P 515242-A

SEWAGE DISPOSAL SYSTEM
HOWARD COUNTY HEALTH DEPARTMENT
BUREAU OF ENVIRONMENTAL HEALTH
410-313-2640

SUBDIVISION Monticello LOT NUMBER 30 ADDRESS 14312 Fox Creek Court

515242-A

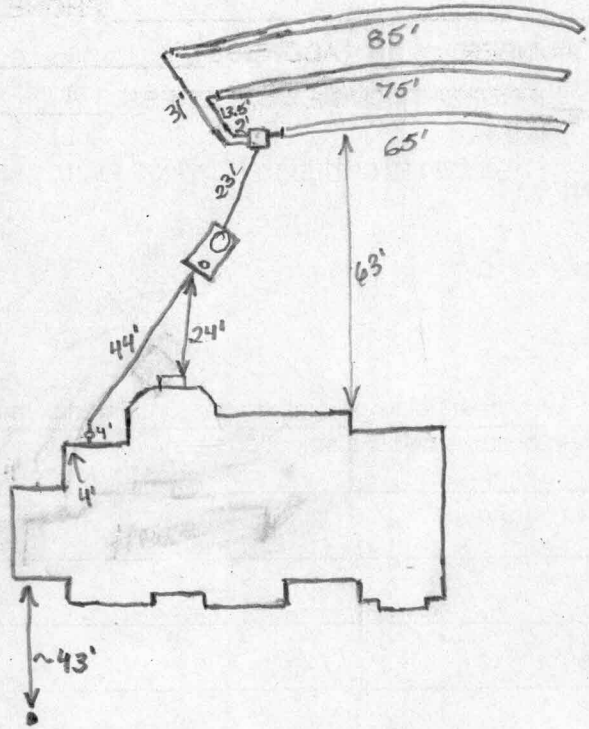
OK to extend upper trenches larger to full edge of septic area for economy: i.e. let 60', next 70',

Site is not contained as on plan. OK to install 2 trenches (112ft long each) if only extends 15-20

feet of SDA and keeps to high part of lot. PIP 5/18/01 (per TC contractor)

PRE-CONSTRUCTION INSPECTION: Layout OK, see modification to specs to allow longer trenches for economy of space. PJP 5/16/01

INSPECTION COMMENTS: House connection partially made, needs rest of pipe to ST. Septic tank set only. PJP 5/17/01
5/18/01 System satisfactory. O.K. to cover. BB
